Approved Development Agreement Site Plan

Lynnett Road
2 0 2 1 . 0 3 . 3 0

Lynnett Road

Move Multi-Family Building

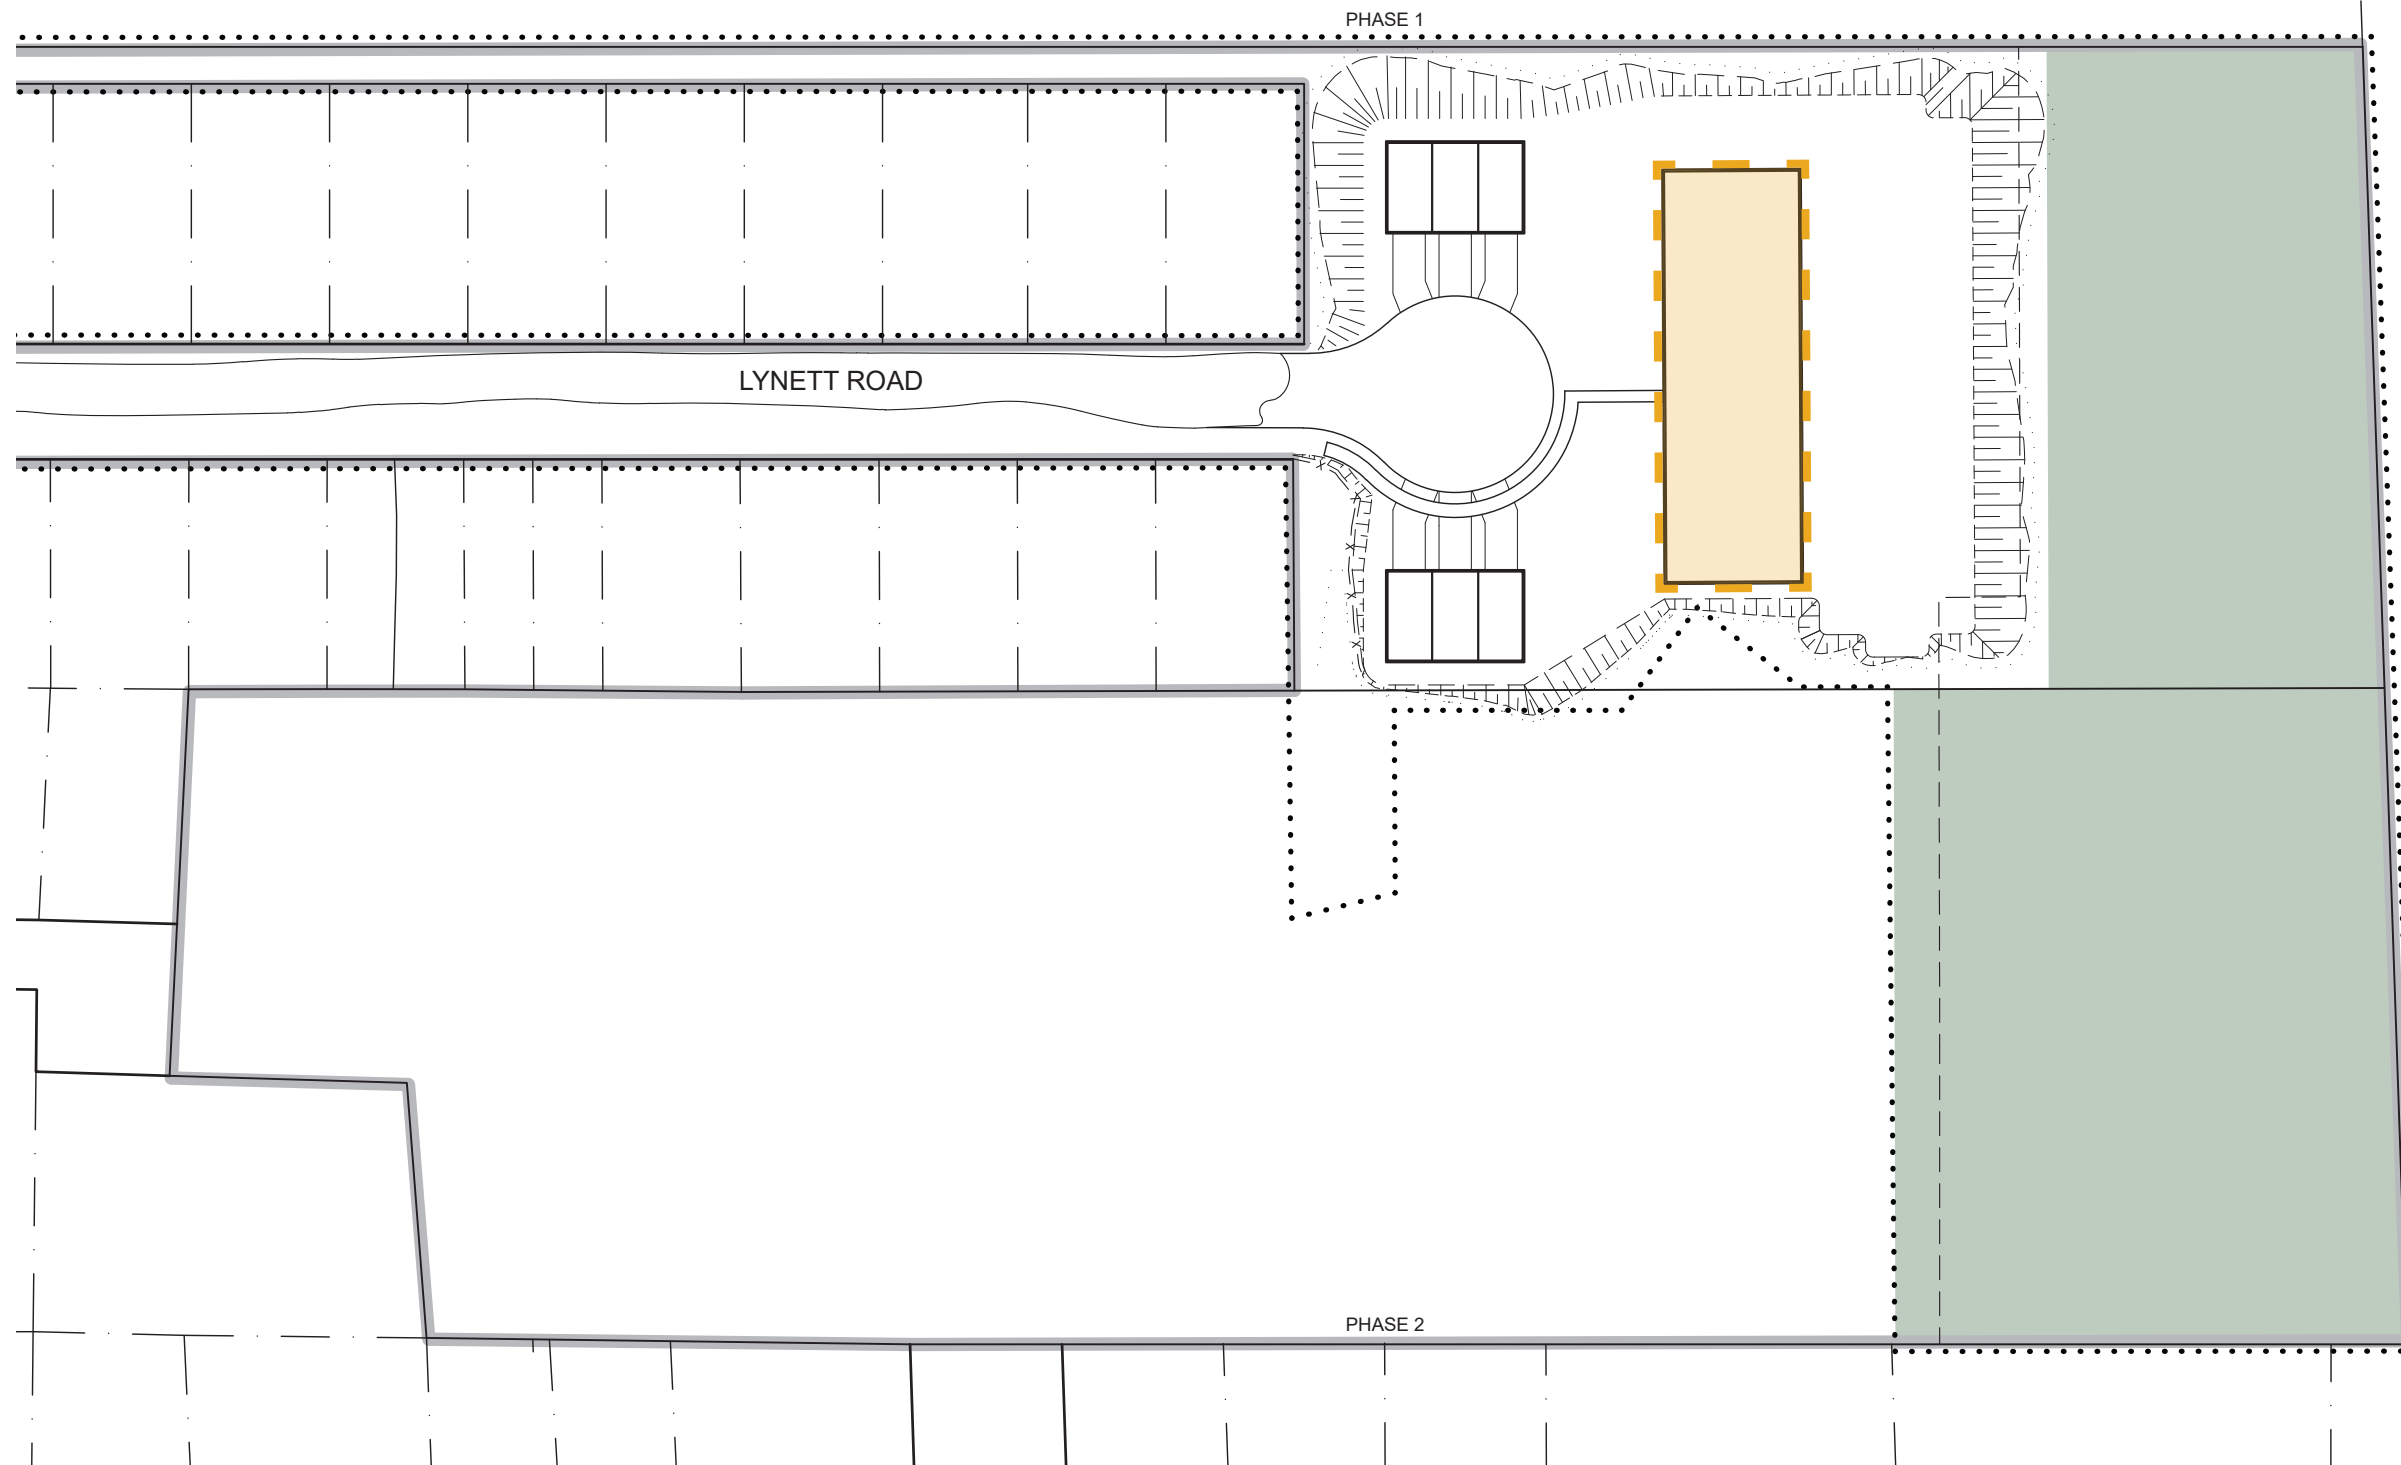
- improves transition from single family to multi-family dwellings

Move Parking

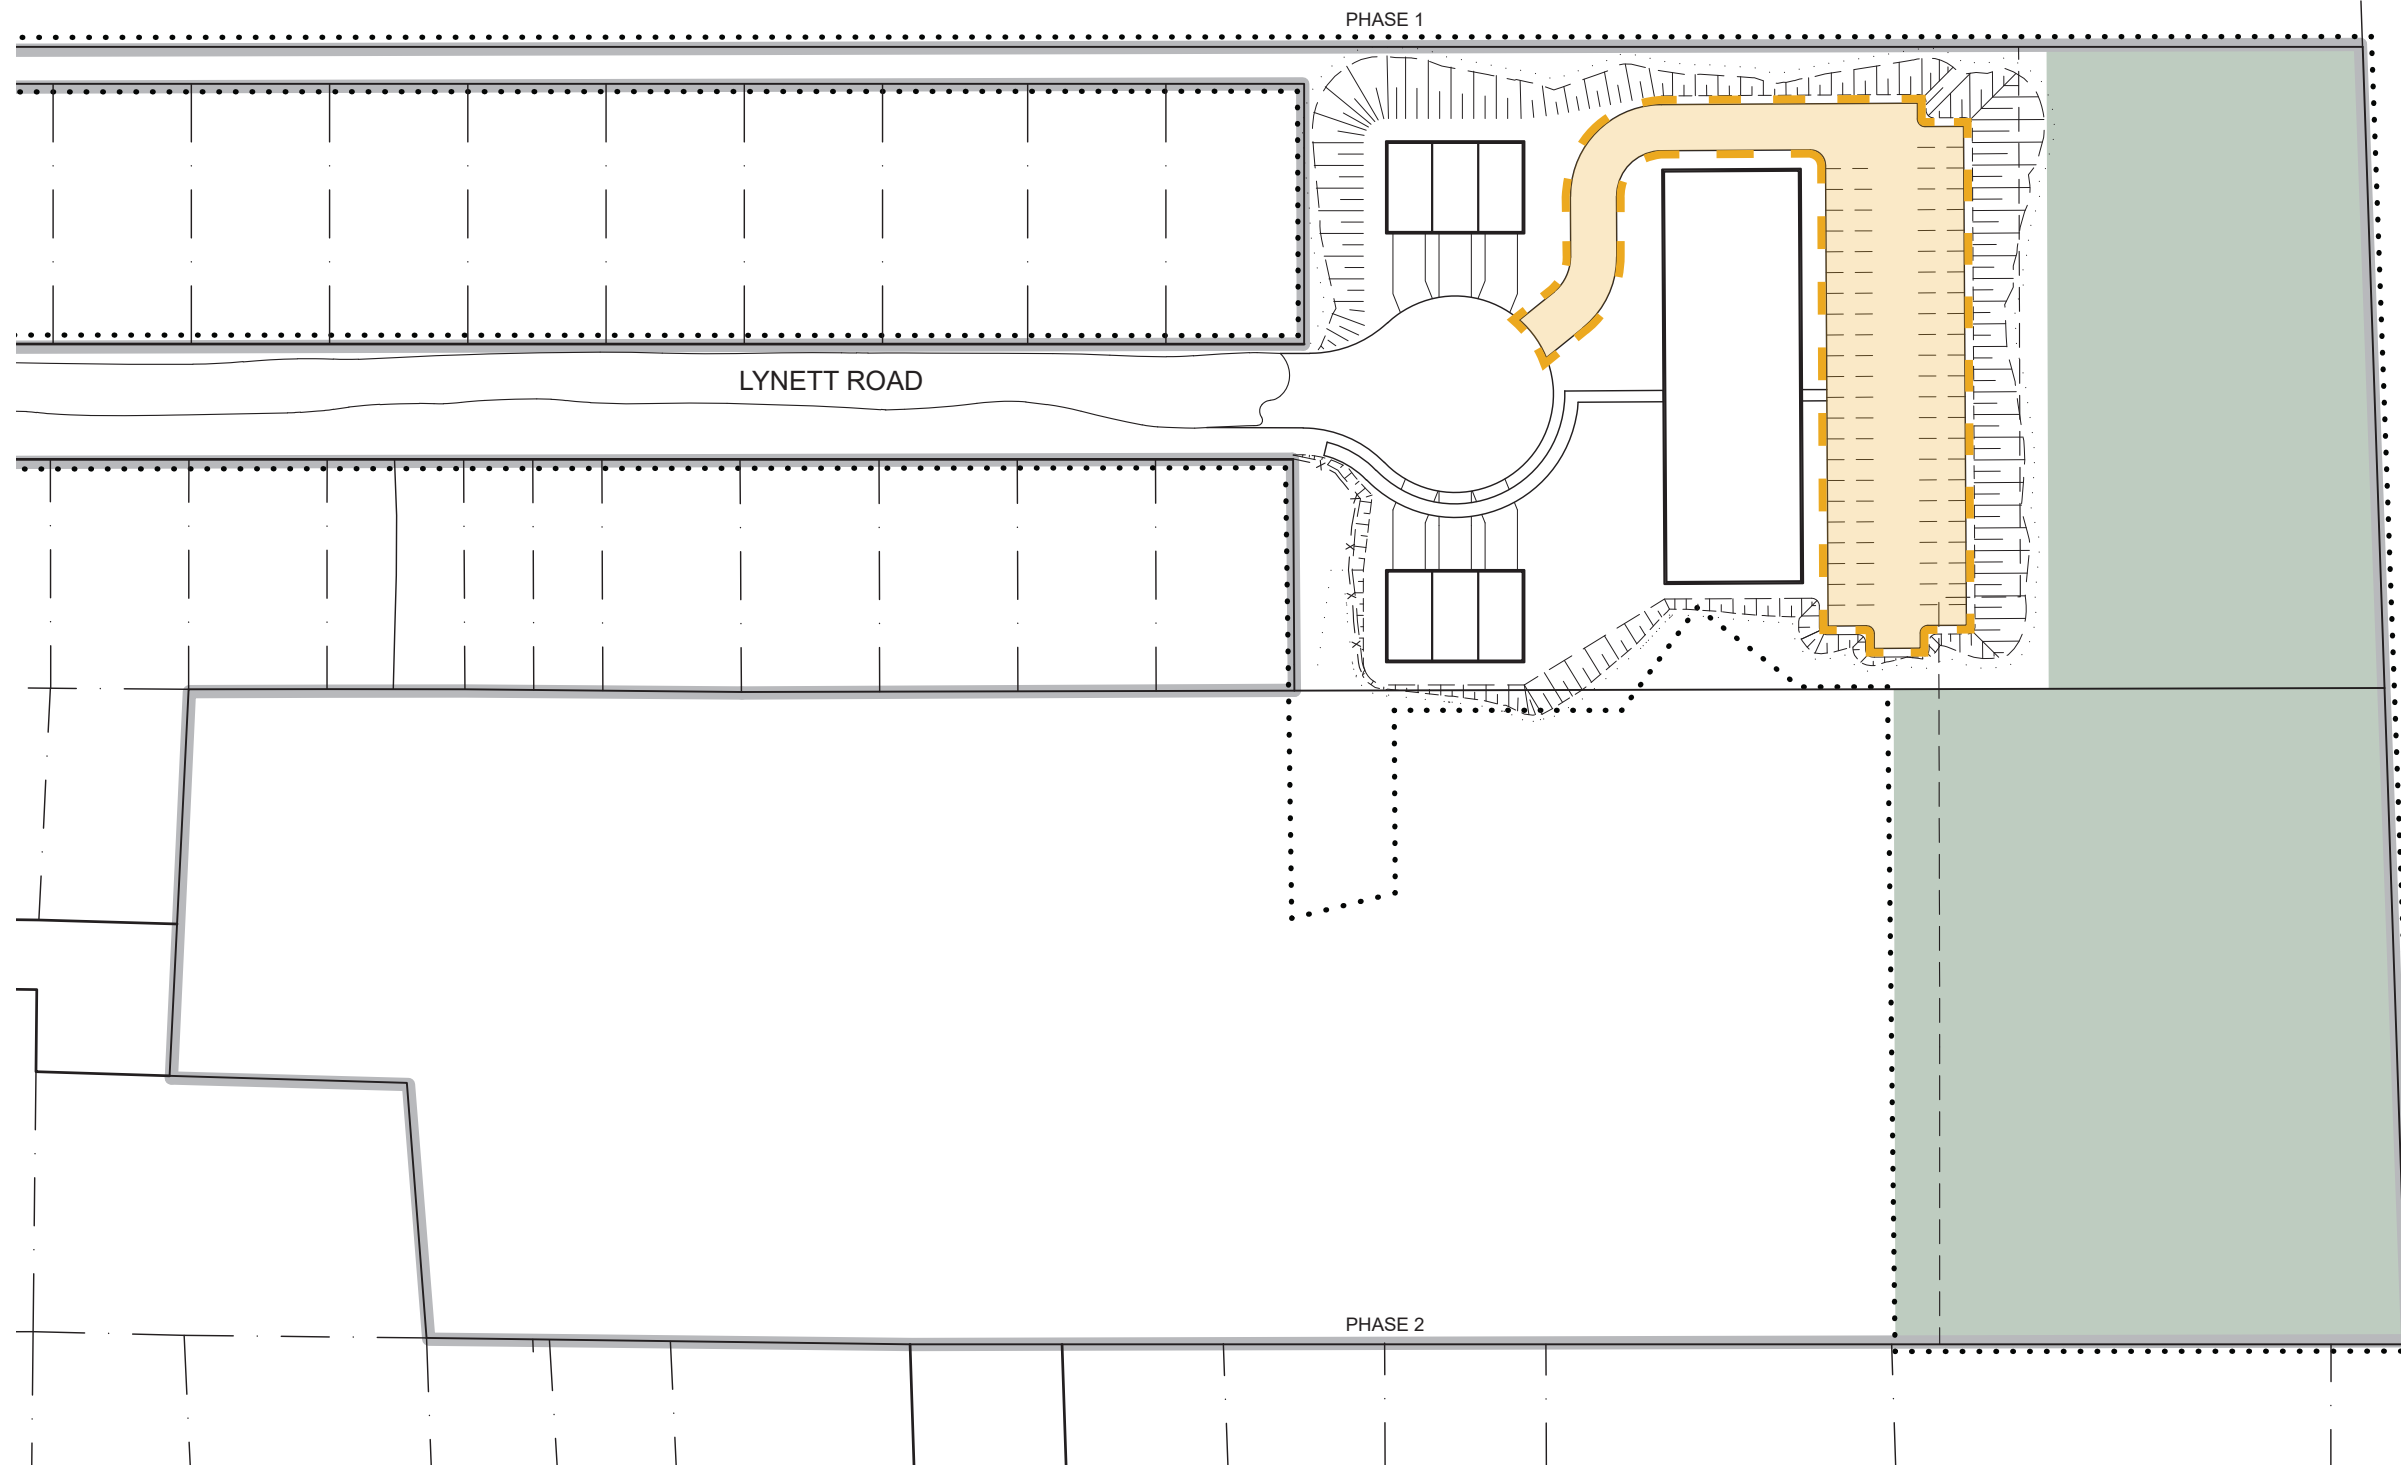
- conceals parking behind multi-family building
- 2 options for parking will be presented

Site Section

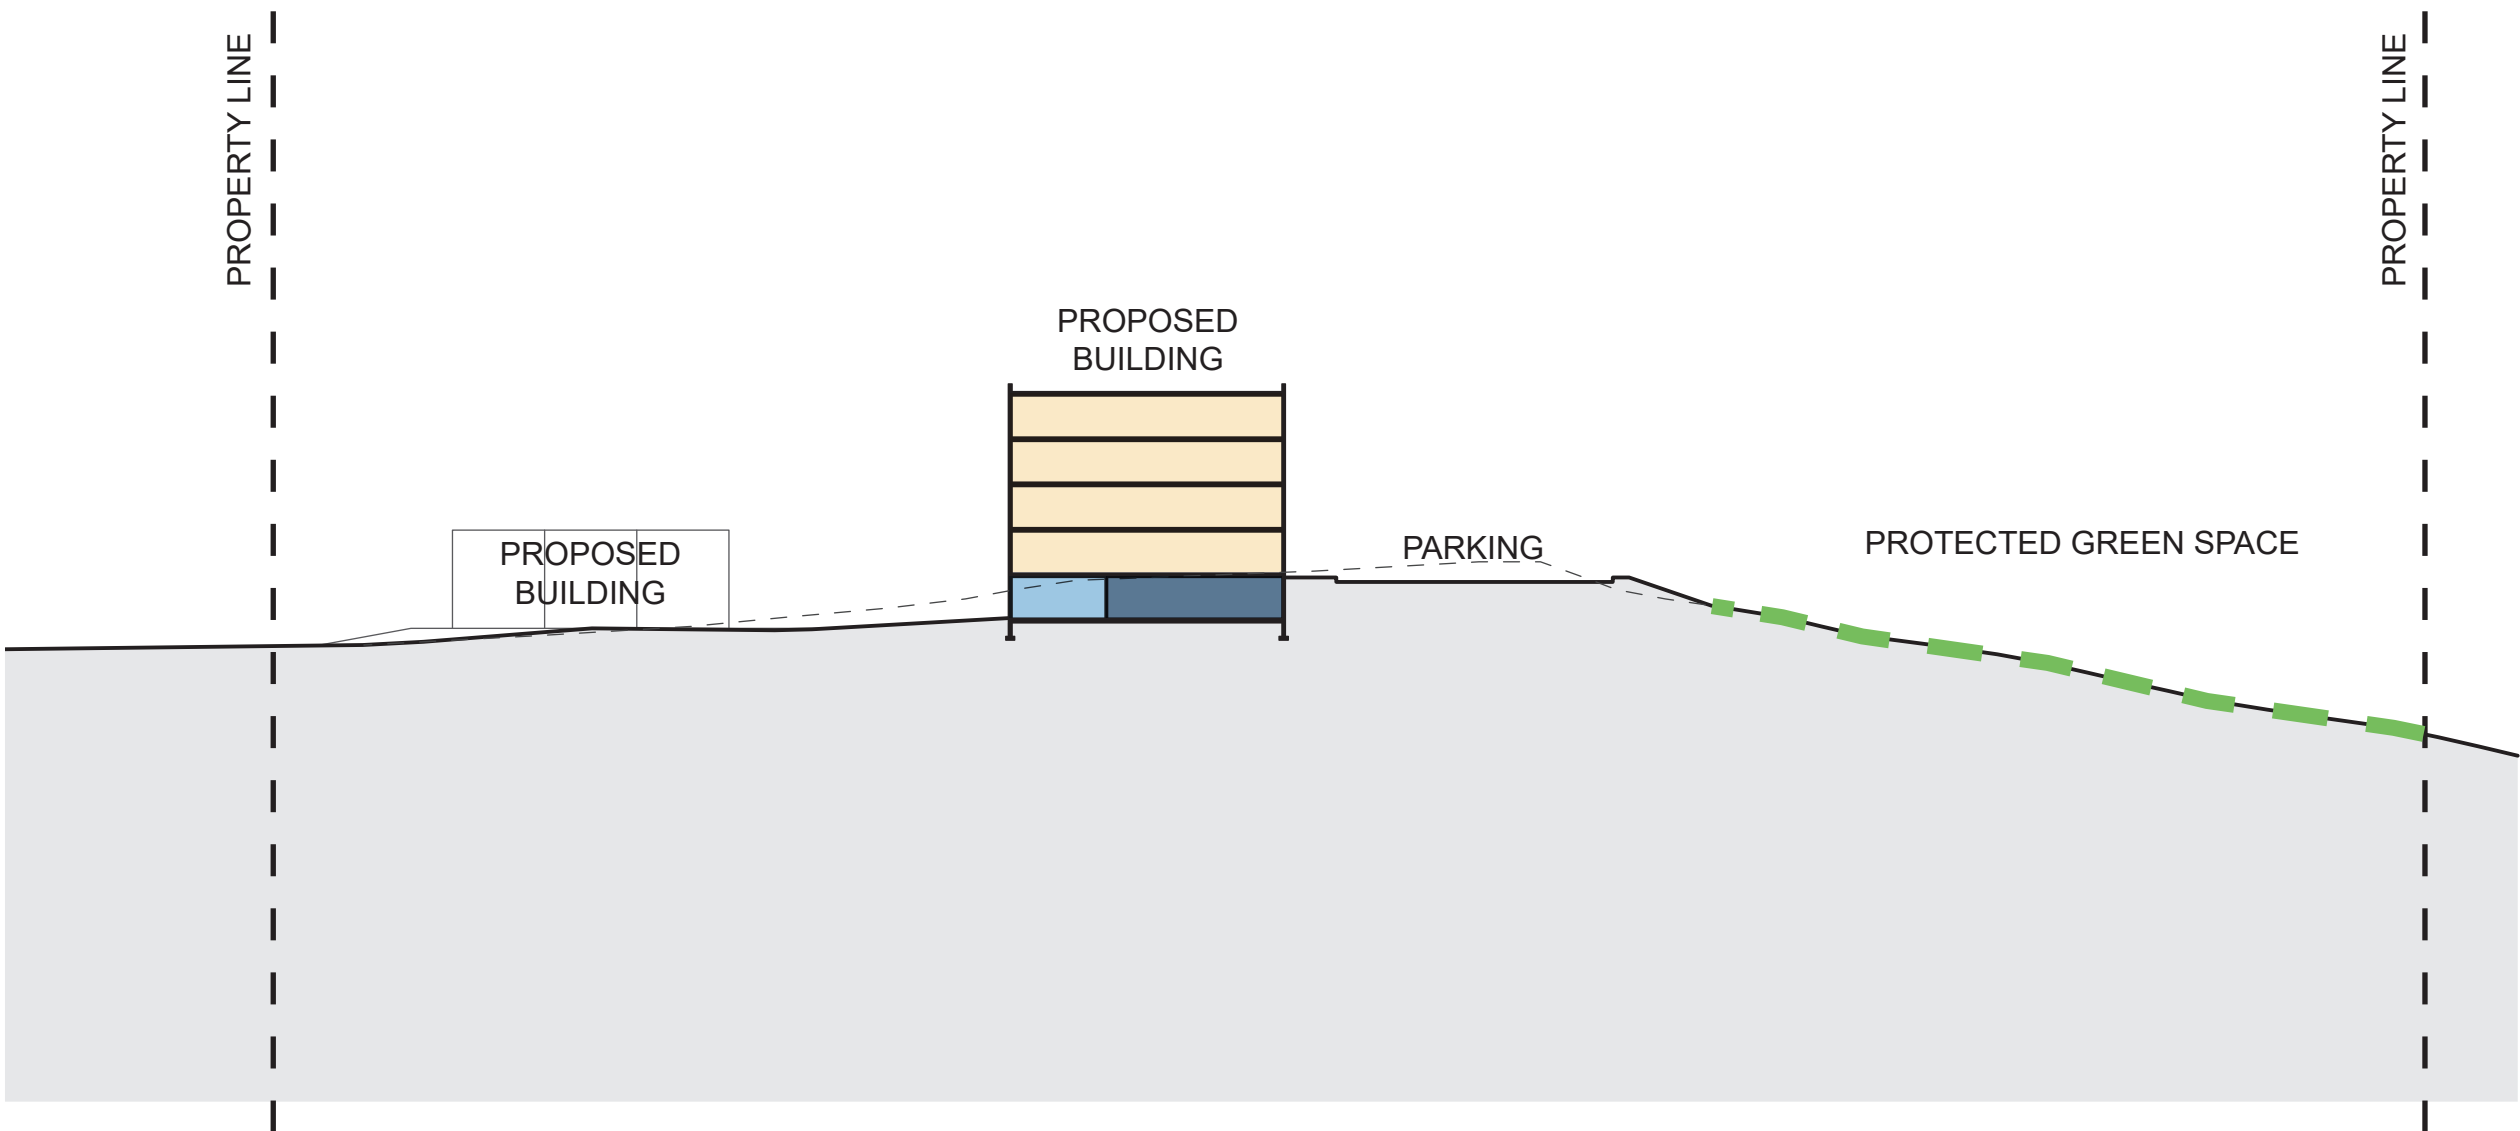
- under building parking to be determined by geological conditions during excavation
